Subject: AP1000 COL Response to Request for Additional Information (TR #3)

1. Response to Request for Additional Information on Technical Report No. 3, RAI-TR03-013

RAI Response Number: RAI-TR03-013  
Revision: 0

Figure 3G.2-12 – Coarse model of containment internal structures.

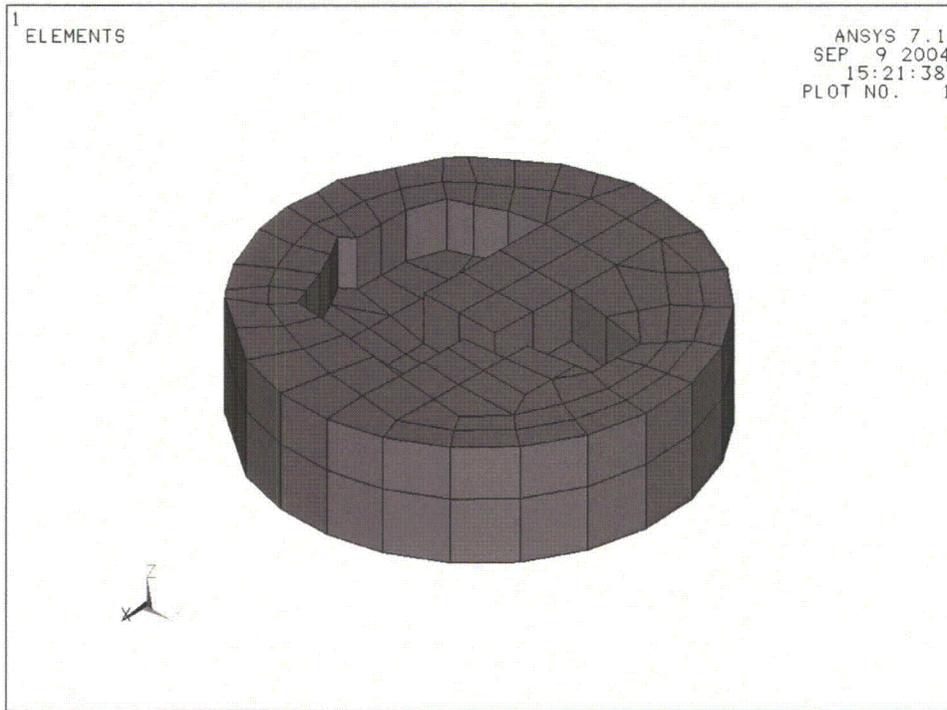
The first row of the first column of Table 4.2.4-1 describes the shield and auxiliary building model as "3D finite element coarse shell model of auxiliary and shield building [NI20] (including steel containment vessel, polar crane, RCL, and pressurizer). The staff's question is that should the CIS also be included in the model?"

This RAI is similar to RAI-TR03-008 and a response is provided in the response to RAI-TR03-008.
